**Re: Proposed Change to Biglow Canyon Wind Farm: Request for
Department of Energy Determination Pursuant to OAR 345-027-
0050(5)**

| OVERALL SITE PLAN SWITCHYARD AND O&M | | | | | | | |

Re: Biglow Canyon Wind Farm
Change Request #4
Additional O&M buildings

OVERALL SITE PLAN
 SCALE: 1"=40'

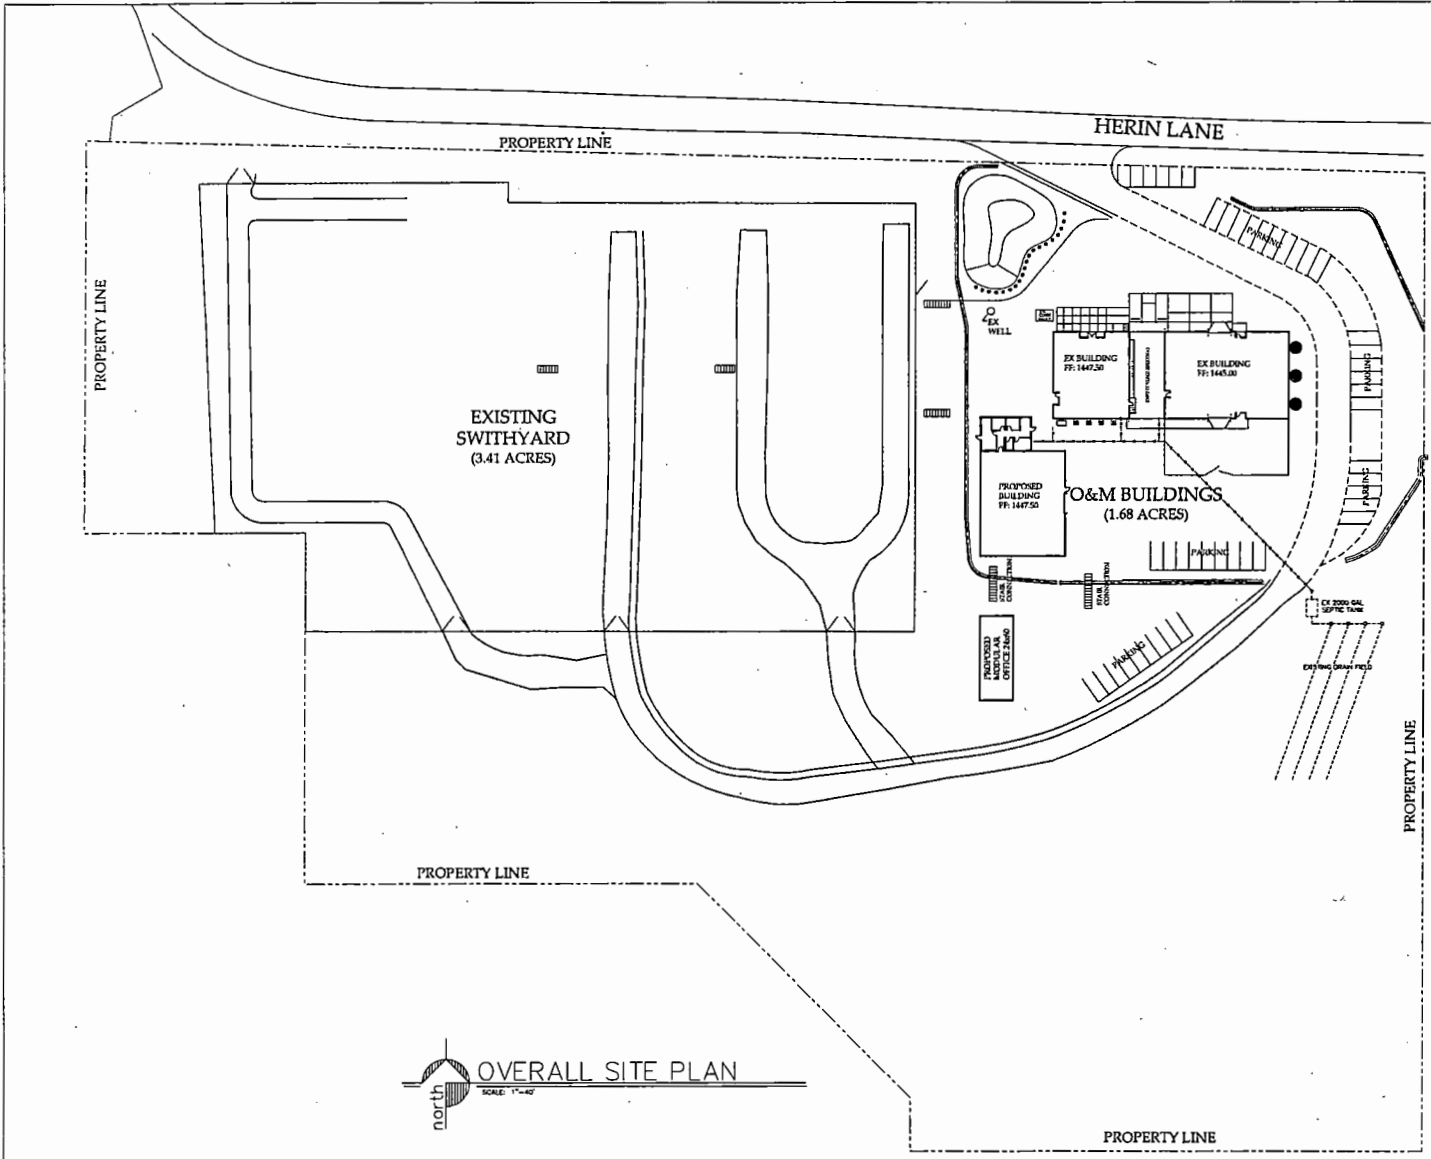
The new warehouse PGE is proposing will be located on the approved five-acre O&M site south of Herin Lane, on the southwest corner of the existing O&M facilities. The warehouse will be approximately 5200 square feet and will be used by Vestas. This building will be permanent and similar in appearance to the existing O&M building.

The new office building will be located to the south of the location of the new warehouse. This office building will be a single level, approximately 1500 square foot modular building and occupied by Vestas. This building will also be permanent and will provide work stations for the technicians that will operate the wind farm.

As described in your request, two new structures would be built within the previously-approved five-acre O&M facility site. No expansion or modification of the site boundary would be necessary. The new structures would consist of a warehouse (approximately 5,200 square feet) and an office building (approximately 1,500 square feet). The warehouse would be "similar in appearance" to the existing O&M building. Both of the new structures would be built in compliance with Conditions 50 (specifying finish) and 51 (specifying design consistent with the character of buildings used by farmers and ranchers in the area). The new structures would comply with Condition 20, which specifies setback requirements consistent with County ordinances. Water for the new structures would be supplied from the existing well, in compliance with Condition 75. Sanitary wastewater disposal would be discharged to the existing county-permitted septic system, in compliance with Condition 83. For these reasons, we conclude that the construction of additional O&M facilities within the previously-approved site would be "in substantial compliance with the terms and conditions of the site certificate."

For the reasons discussed above, we have determined that a site certificate amendment proceeding is unnecessary and that you may construct the two new structures described in your letter of July 8. Please include a description of this change request and our determination in the next annual report required under OAR 345-026-0080 and Condition 122. In the annual report, please describe any unanticipated impacts that result from construction of the new O&M facilities and describe how PGE addressed those impacts.
